<b>Subject:</b>  <b>KNOCKING / SQUEAKING NOISE FROM FRONT STRUT BEARING</b>	<b>Bulletin No:</b> 02-005/13
	<b>Last Issued:</b> 11/11/2013

## BULLETIN NOTE

- This bulletin supersedes the previous bulletin 02-005/13, issued on 08/24/13. The APPLICABLE MODEL(S)/VINS, and REPAIR PROCEDURE have been revised.
- Changes are noted below in Red beside the change bar.

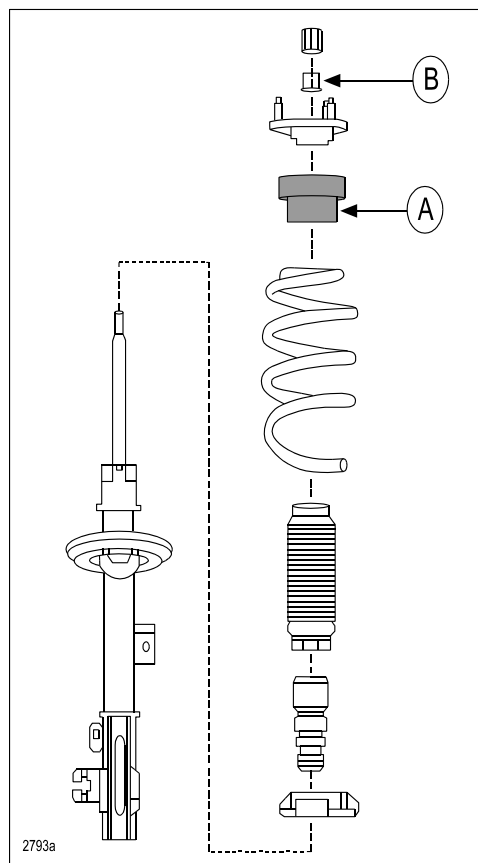
Some vehicles may exhibit a knocking / squeaking noise from the front strut bearing (A) due to front strut bearing damage when driving on rough roads and/or when turning the steering wheel while the vehicle is stopped.

The noise may be due to the upper housing of the front strut bearing being damaged when applying excessive force to the bearing during customer use. To eliminate the noise, the material and production method of the front strut bearing has been changed.

**NOTE:** The piston rod nut (B) requires replacement when the front strut bearing is replaced.

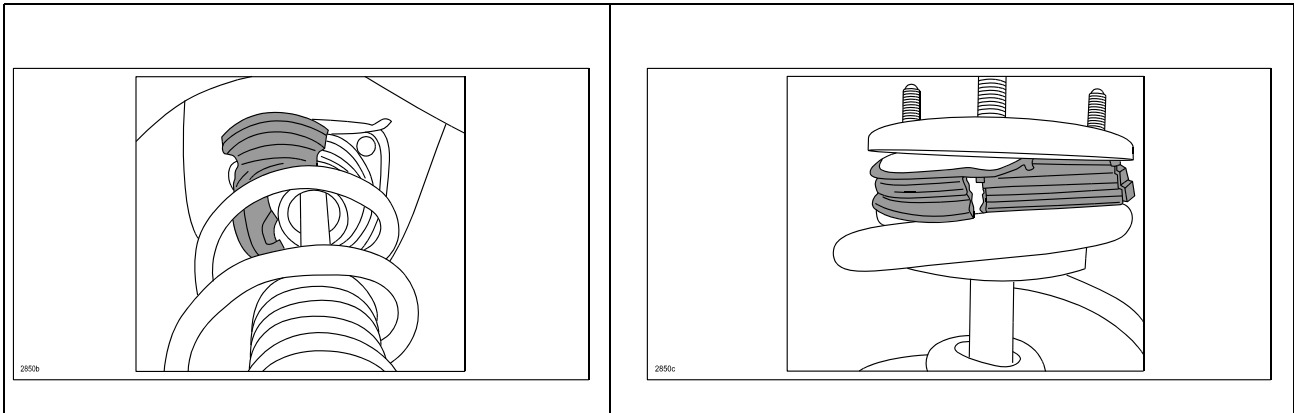
1. Verify customer concern.
2. Is the noise is coming from the upper part of front shock absorber when turning the steering wheel?
  - Yes - Proceed to step 3.
  - No - This bulletin does not apply.
3. Is the strut bearing broken as shown below?
  - Yes - Proceed to step 6.
  - No - Proceed to step 4.

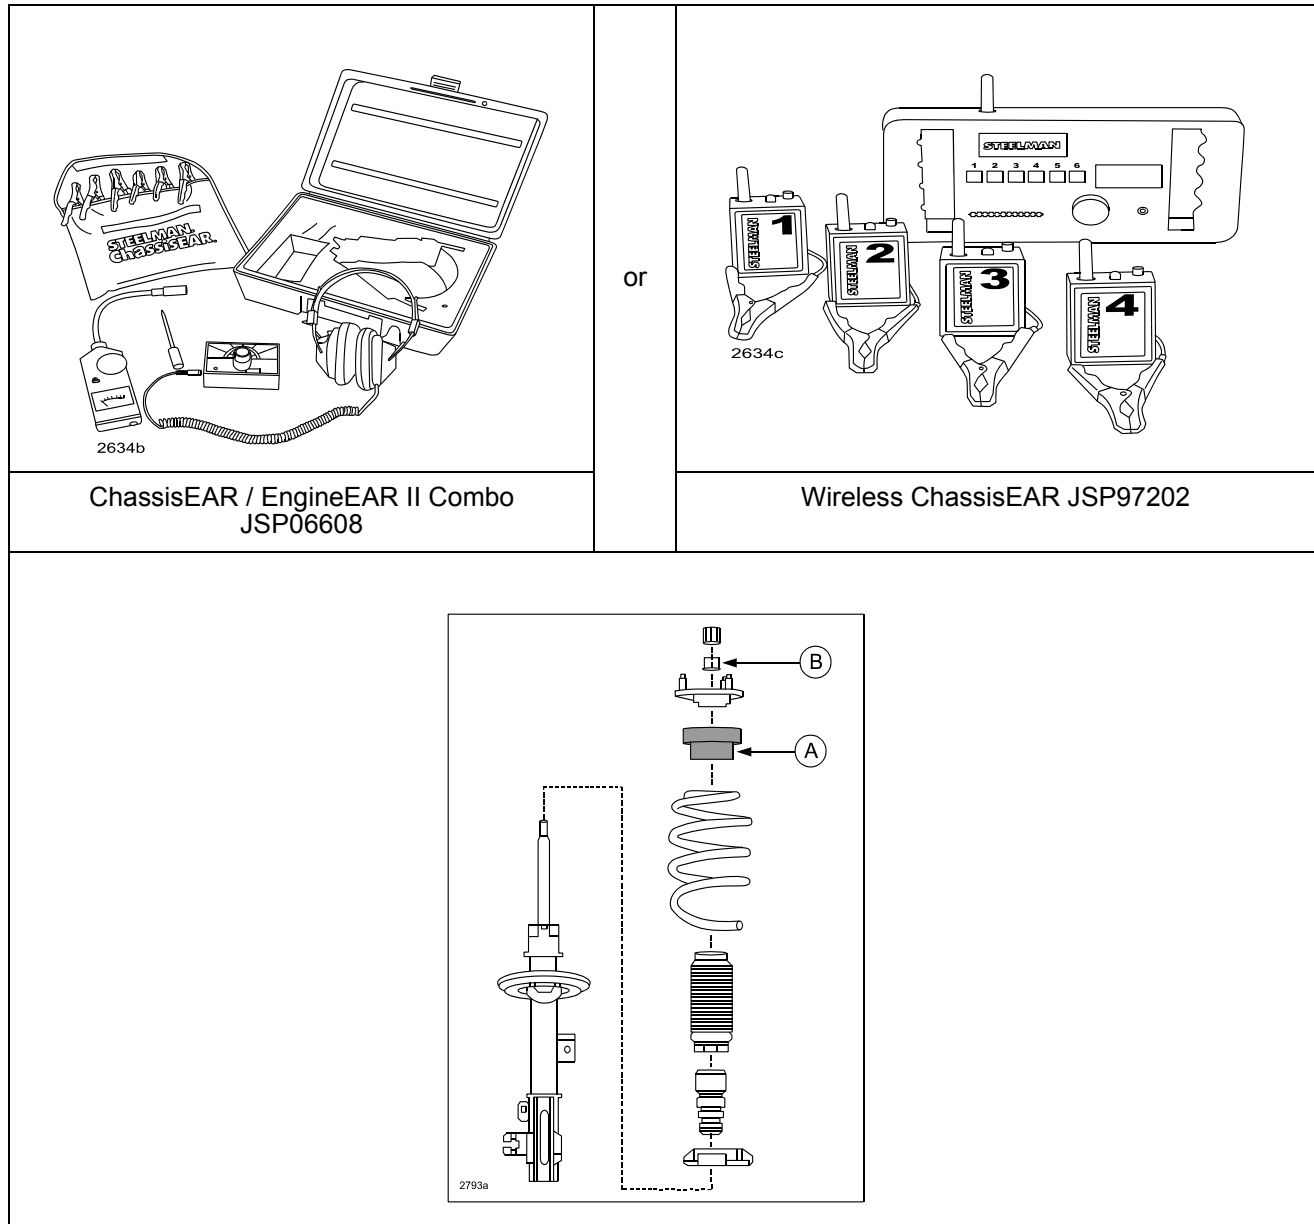
4. Use Special Service Tool (SST) ChassisEAR / EngineEAR II Combo JSP06608 or Wireless ChassisEAR JSP97202 to confirm noise is coming from the upper part of front shock absorber (A) (shown below):

5. Using ChassisEAR SST, is the noise is coming from the upper part of front shock absorber?
- Yes - Proceed to step 6.
  - No - This bulletin does not apply.
6. Replace the front strut bearing with a new one according to MS3 online instructions or the Workshop Manual (section 02-13 FRONT SHOCK ABSORBER AND COIL SPRING DISASSEMBLY/ASSEMBLY).
7. Verify repair.
